VERMONT YANKEE NUCLEAR POWER STATION

AMENDMENT TO FACILITY OPERATING LICENSE

Amendment No. 90
License No. DPR-28

SAFETY EVALUATION BY THE OFFICE OF NUCLEAR REACTOR REGULATION
SUPPORTING AMENDMENT NO. 90 TO FACILITY OPERATING LICENSE NO. DPR-28
VERMONT YANKEE NUCLEAR POWER CORPORATION
VERMONT YANKEE NUCLEAR POWER STATION
DOCKET NO. 50-271

FIGURE 6.1.1
OFFSITE SUPPORT ORGANIZATION

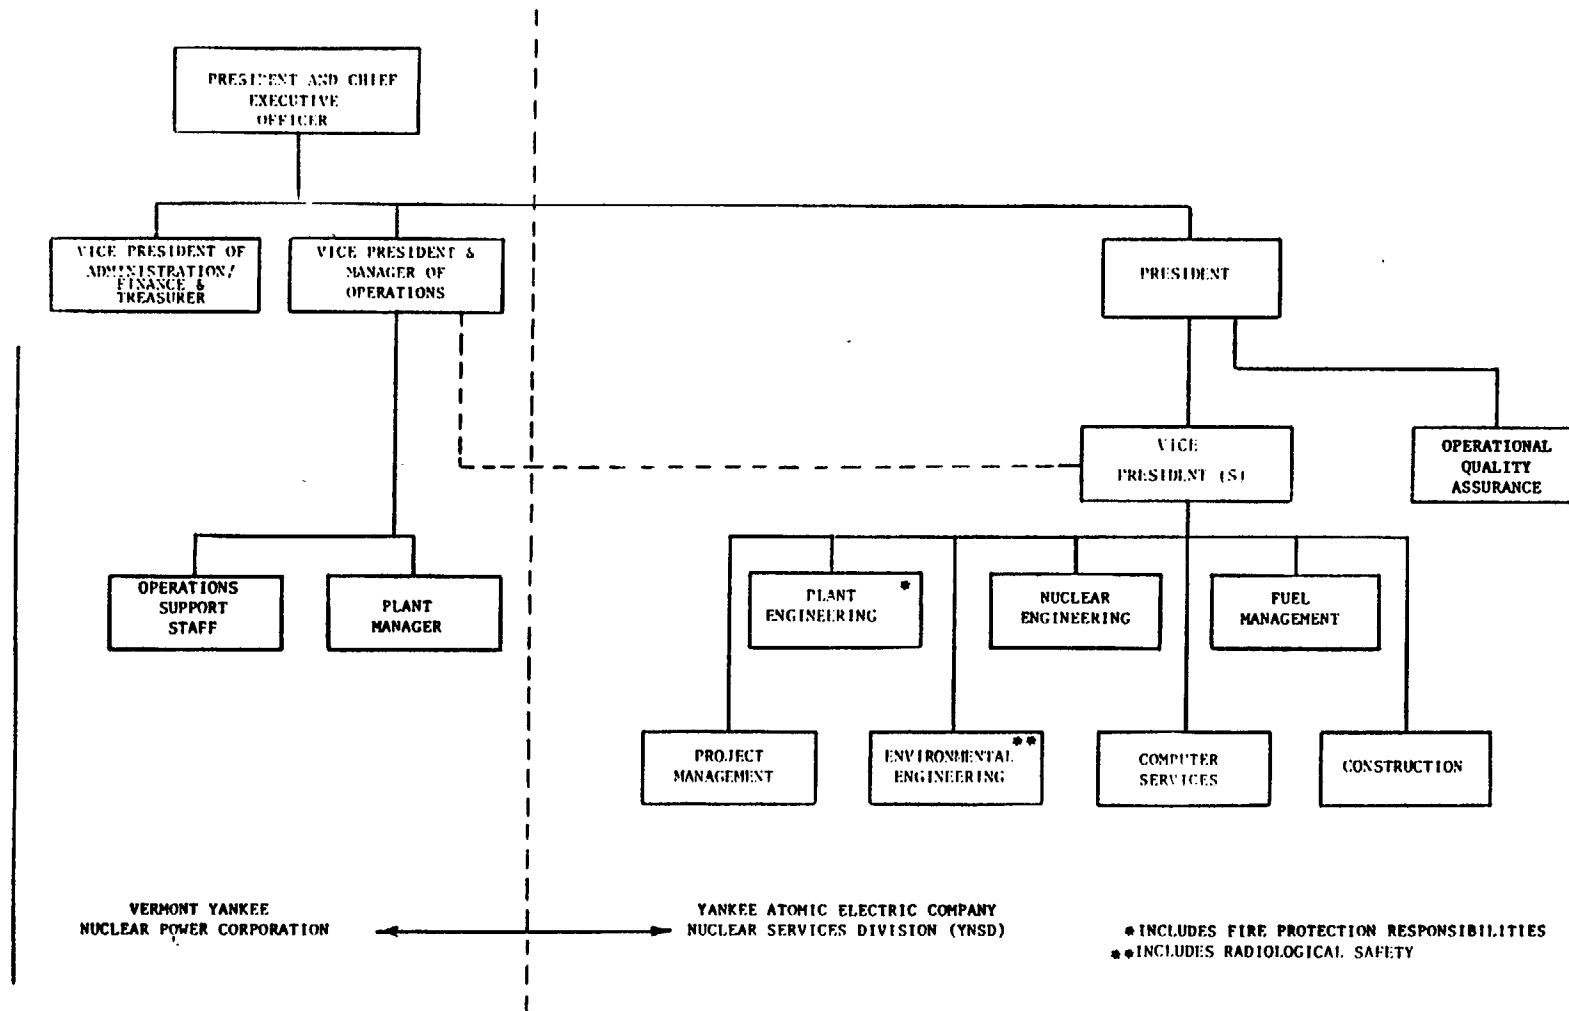
Figure 6.1.1 is revised to update the organization of the Nuclear Services Division of the Yankee Atomic Electric Company, which provides offsite engineering support to the Vermont Yankee plant. The "Vice President--Operations" position is deleted, and the Plant Engineering function that formerly reported to that position is moved under the remaining "Vice President(s)" positions.

In addition, the "Radiological Safety" box on existing Figure 6.1.1 is deleted and a footnote is added to show that the "Environmental Engineering" function includes radiological safety.

Finally, a new "Project Management" box is added to Figure 6.1.1.

The proposed changes described above do not affect the scope of offsite engineering support provided by the Yankee Atomic Electric Company. The changes more accurately represent the offsite engineering support organization and are acceptable.

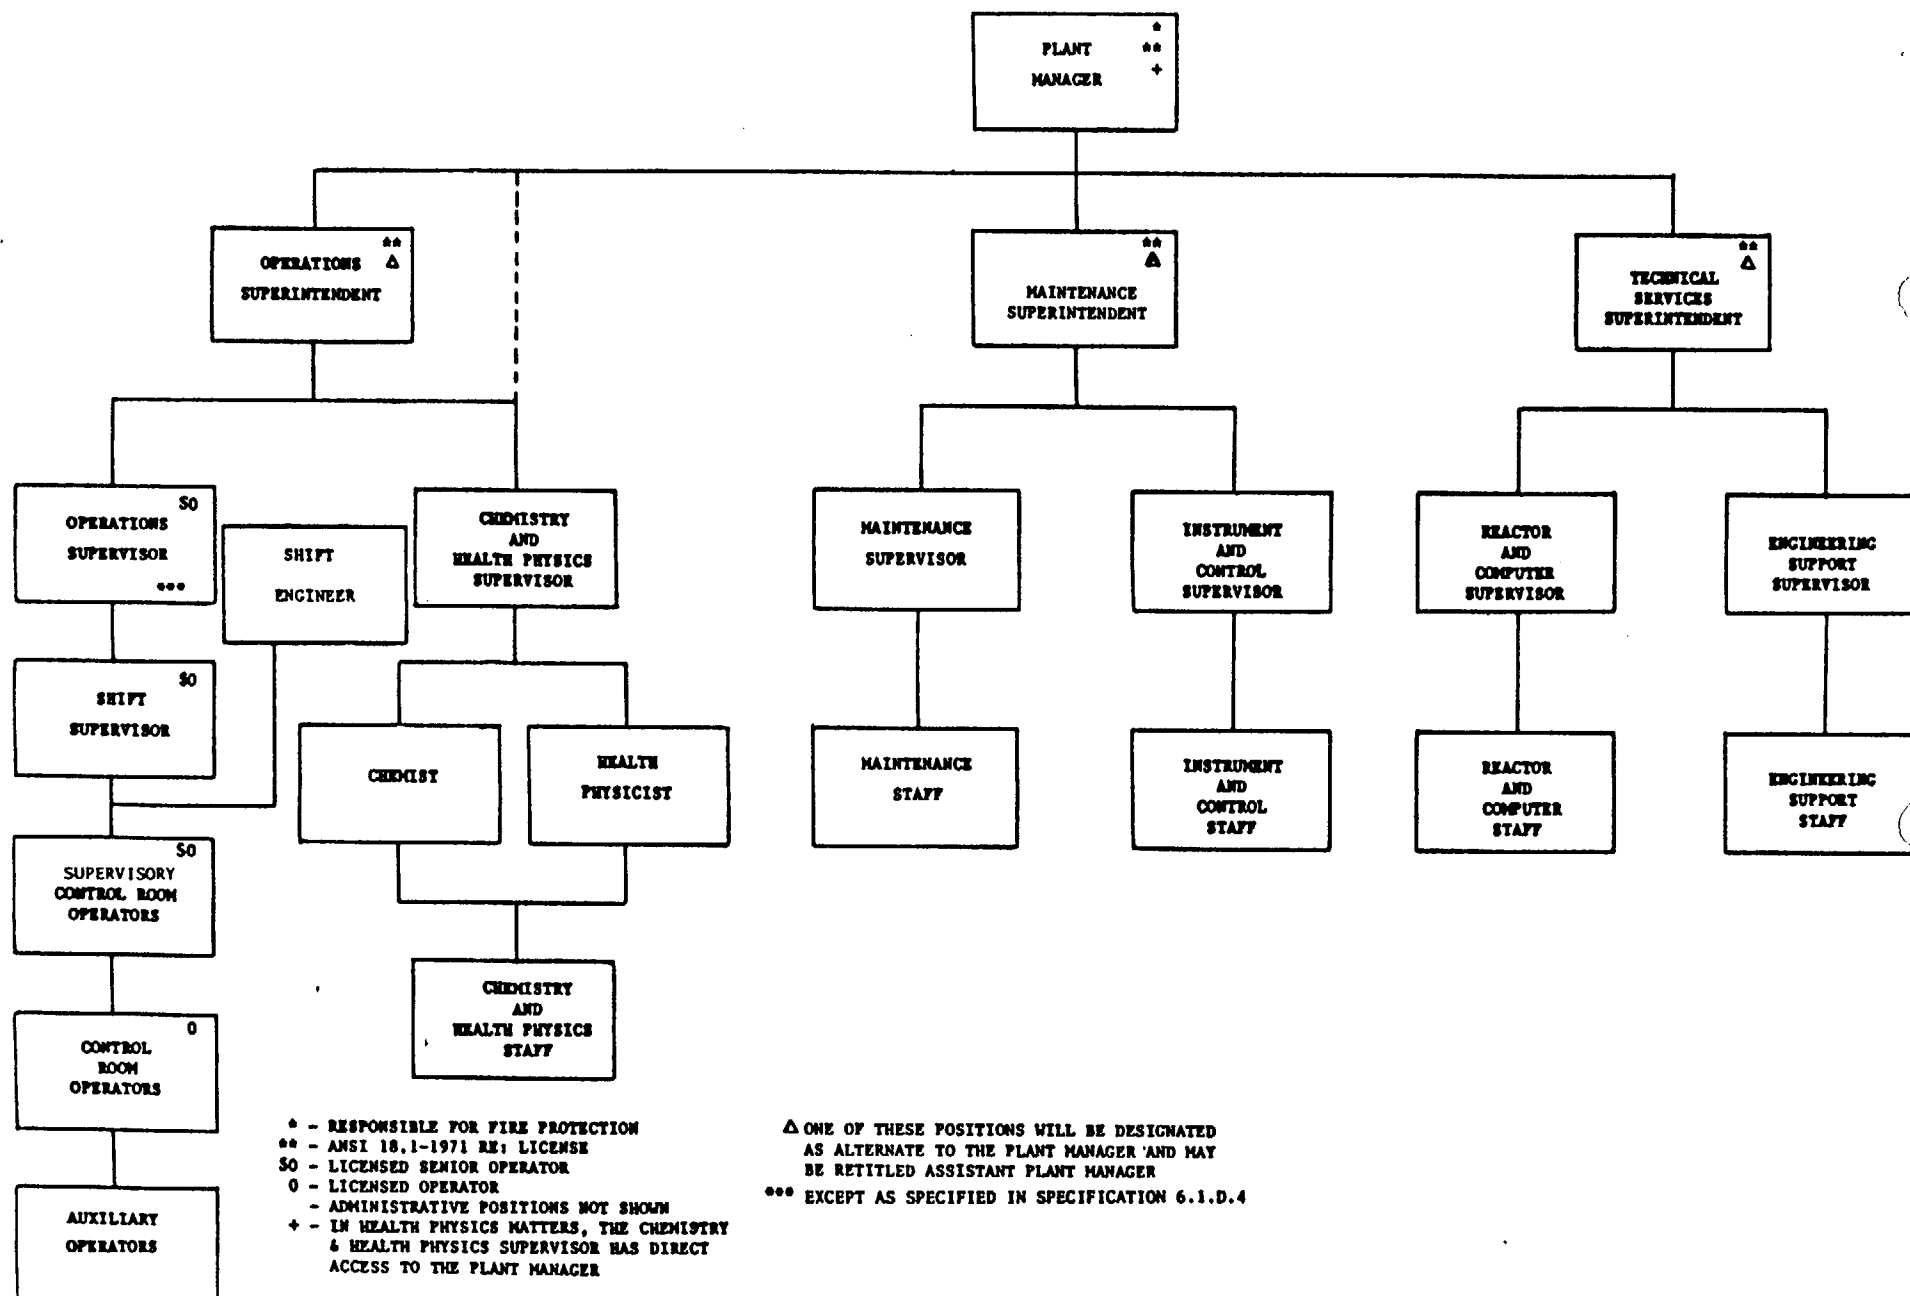
The existing Figure 6.1.2 (on-site organization chart) has a box in the operations chain of command containing the title "Senior Control Room Operators." The revised Figure 6.1.2 uses the title "Supervisory Control Room Operators," which brings the title used in the figure into agreement with the title used in Table 6.1.1. This is an editorial change and is acceptable.
